3.1.1.1 The SHUTDOWN MARGIN shall be greater than or equal to ~~1.3% $\Delta k/k$~~ ^{the limit specified}
in the CORE OPERATING LIMITS REPORT (COLR).
APPLICABILITY: MODES 1 and 2^a.

3.1.1.2 The SHUTDOWN MARGIN shall be greater than or equal to the limits shown in Figures 3.1-1a and 3.1-2a (Unit 1) and Figures 3.1-1b and 3.1-2b (Unit 2), specified in the CORE OPERATING LIMITS REPORT (COLR)

FIGURE 3.1-3

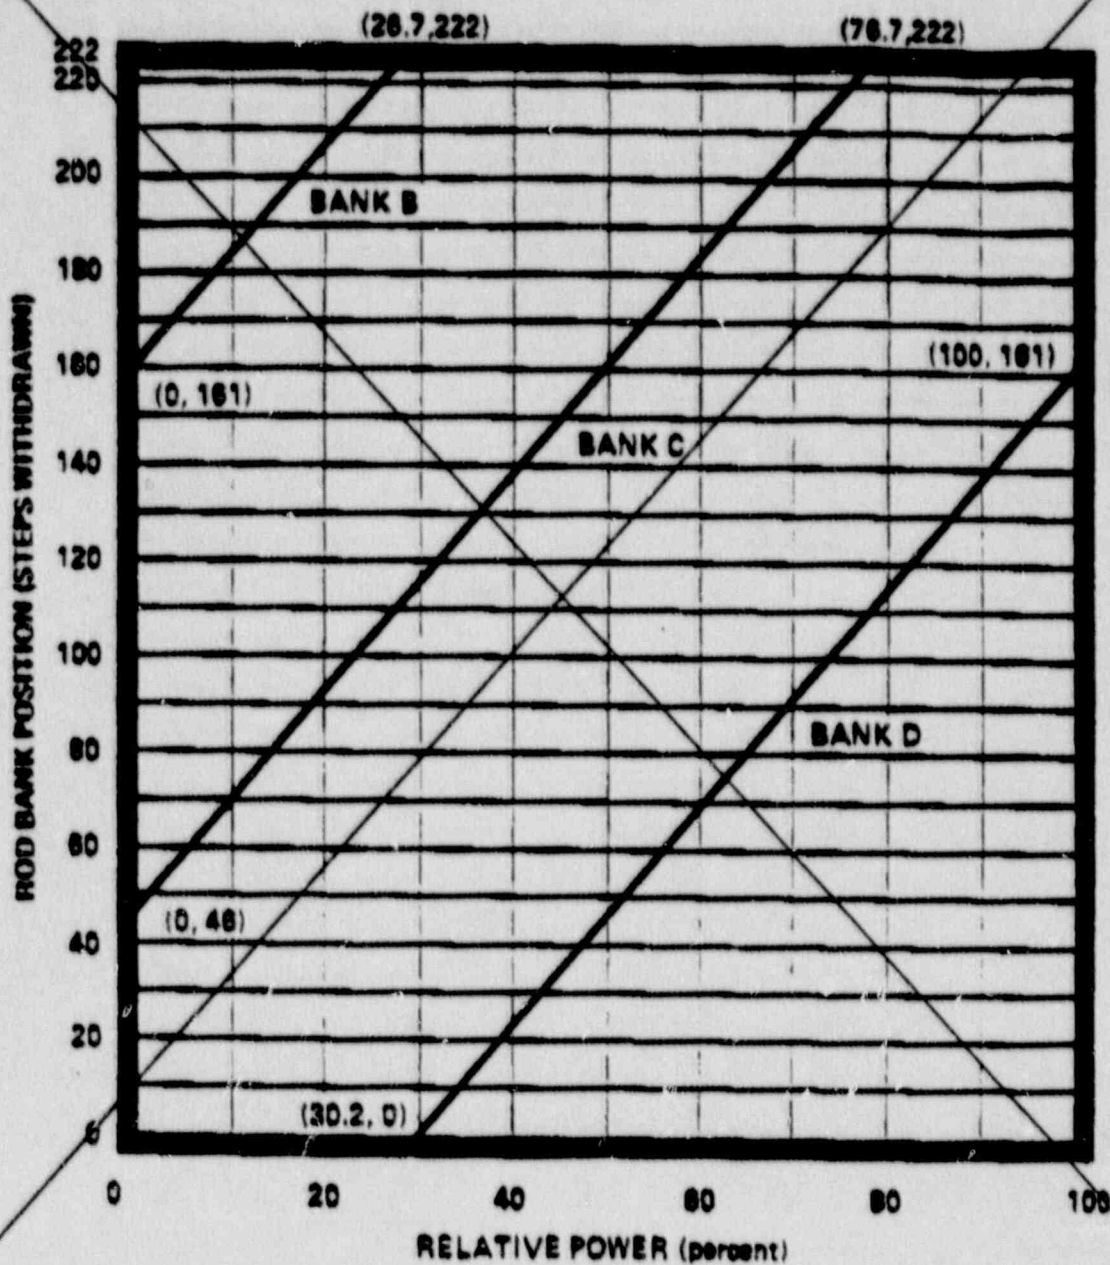
3.1.3.6 The control banks shall be limited in physical insertion as ~~shown in Figure 3.1.3.~~ Specified in the CORE OPERATING LIMITS REPORT (COLR)

FIGURE 3.2-1 (DELETED)

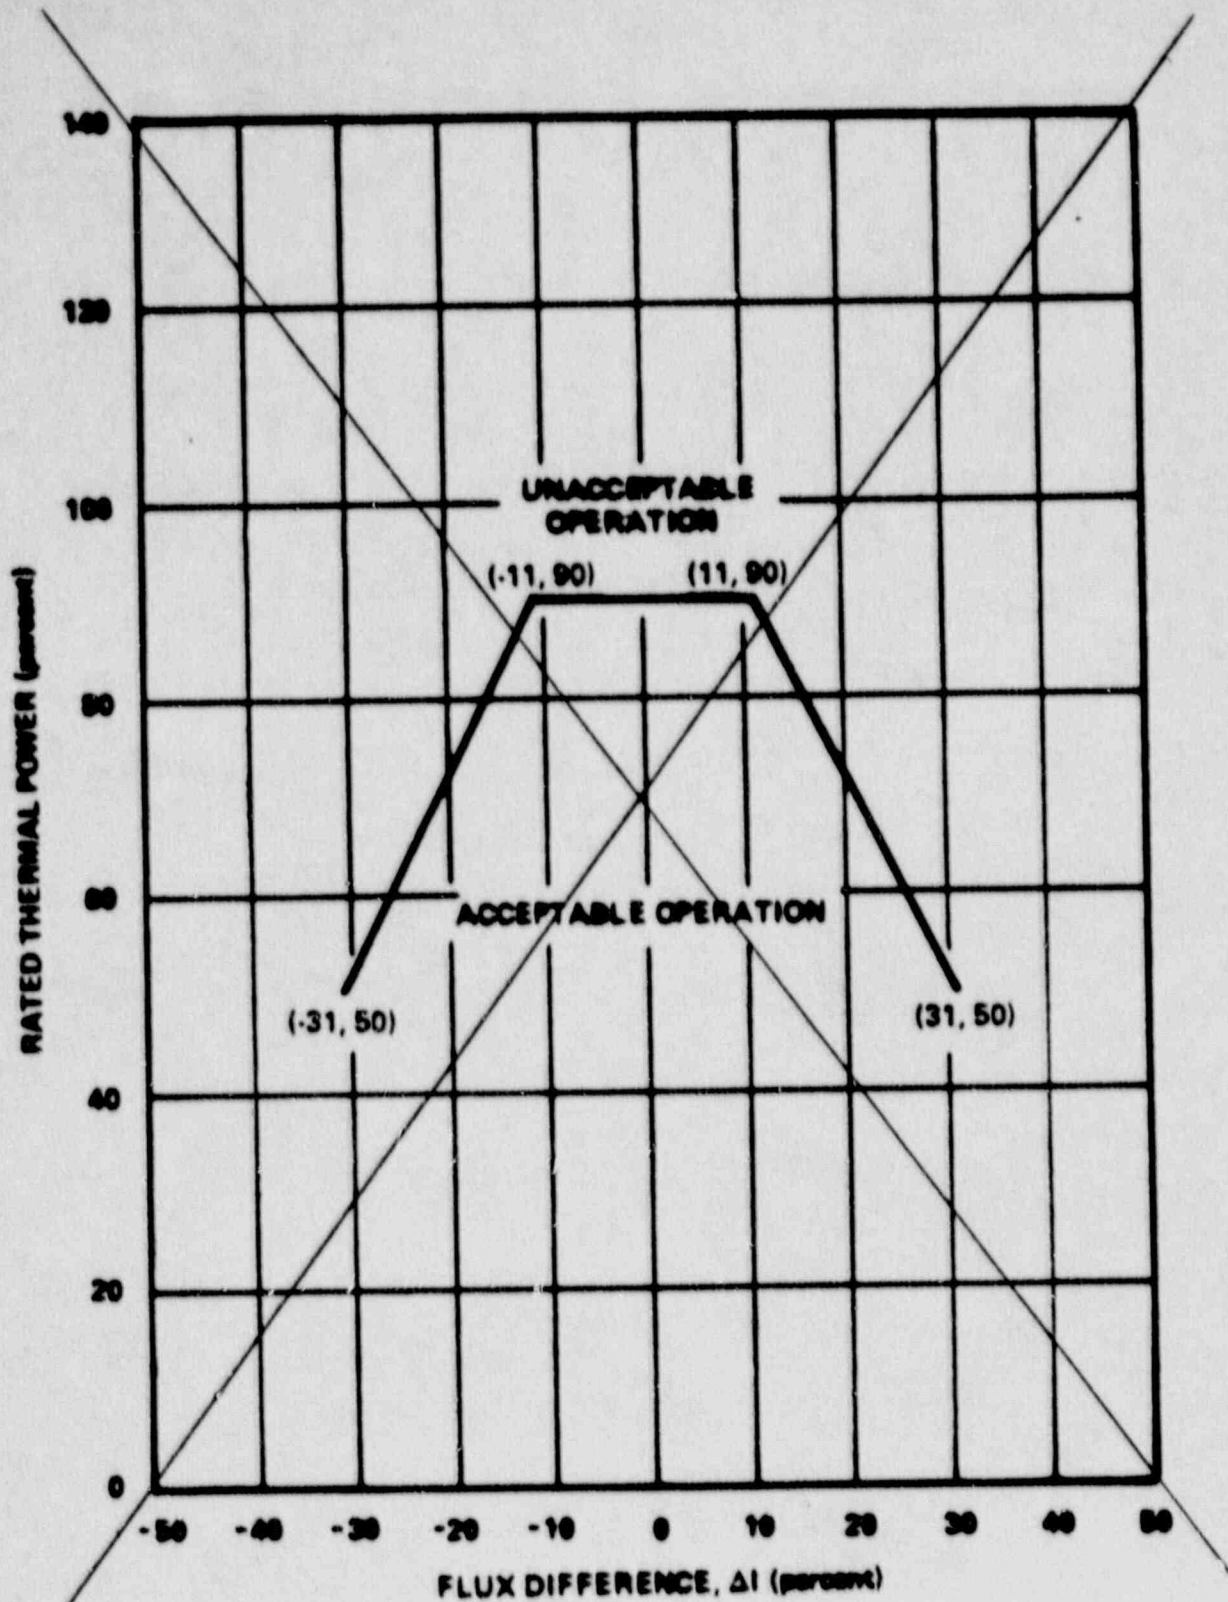
The indicated AFD may deviate outside the ~~above~~ required target band at greater than or equal to 50% but less than 90% of RATED THERMAL POWER provided the indicated AFD is within the Acceptable Operation Limits ~~of Figure 3.2.1~~ and the cumulative penalty deviation time does not exceed 1 hour during the previous 24 hours.

#Surveillance testing of the Power Range Neutron Flux Channel may be performed (below 90% of RATED THERMAL POWER) pursuant to Specification 4.3.1.1 provided the indicated AFD is maintained within the Acceptable Operation Limits ~~of Figure 3.2.1~~ *Specified in the COLR*. A total of 16 hours operation may be accumulated with the AFD outside of the above required target band during testing without penalty deviation.

FIGURE 3.2-2 (DELETED)

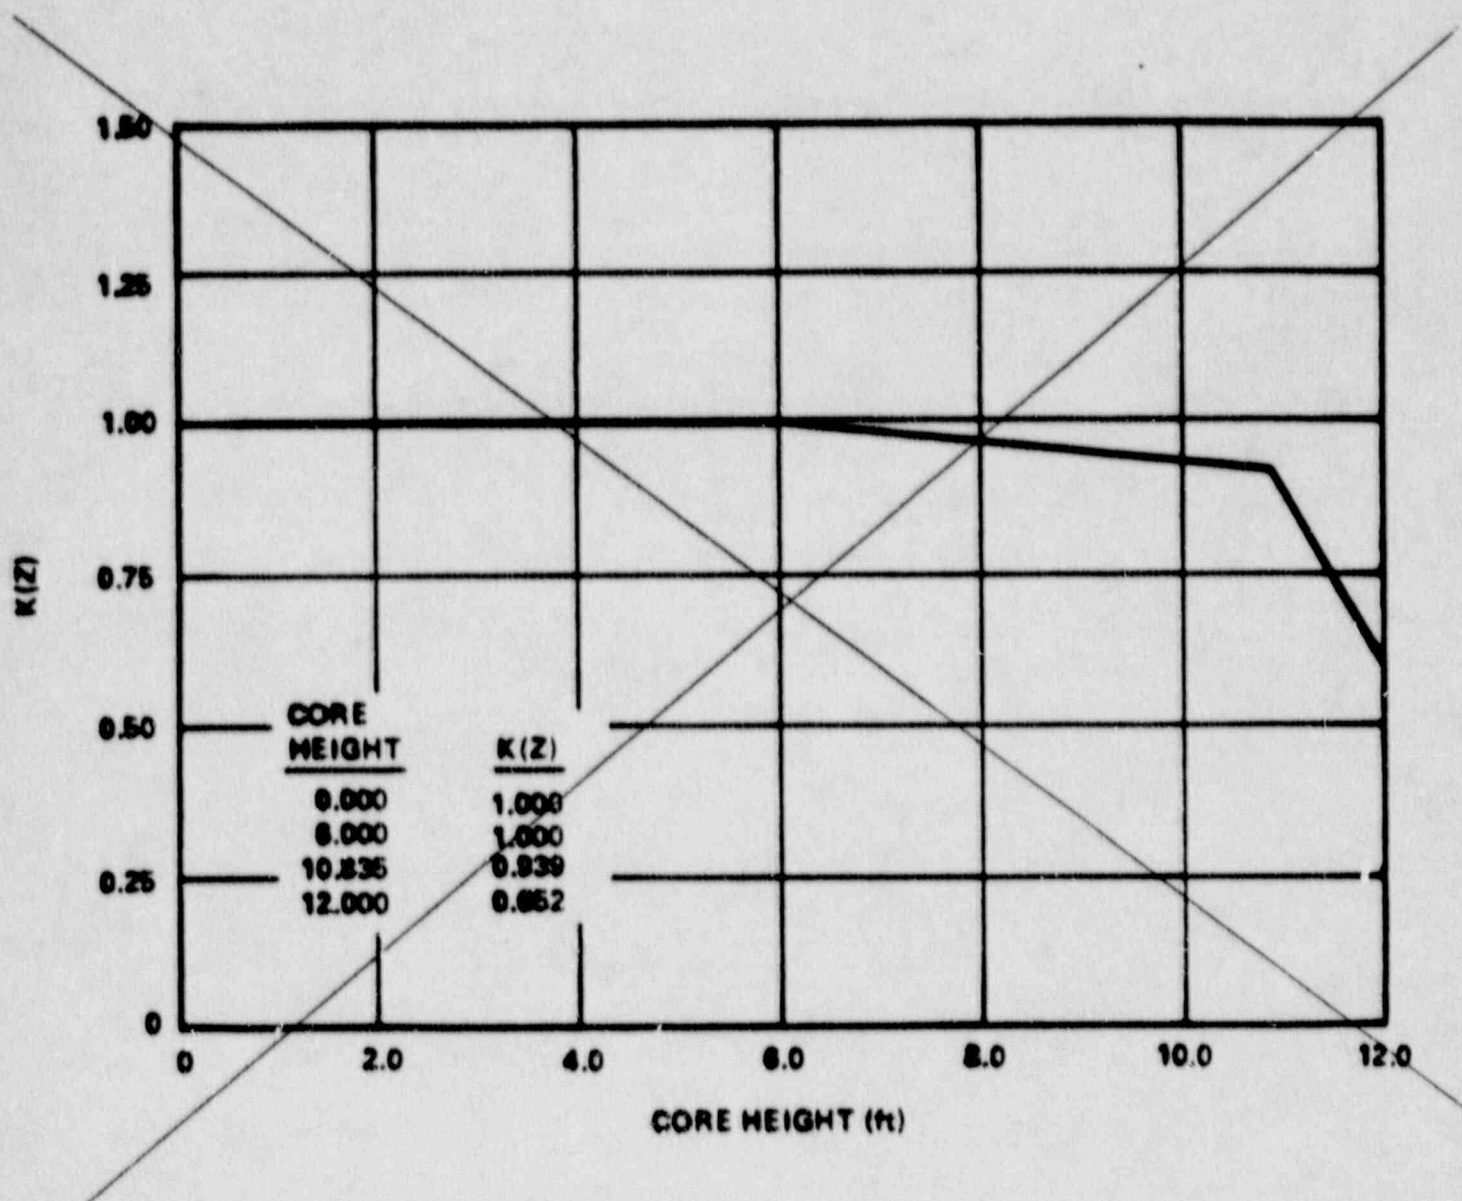
$K(Z)$ = the ~~function obtained from Figure 3.2-2 for a given~~
~~core height location specified in the COLR~~
normalized $F_Q(Z)$ as a function of
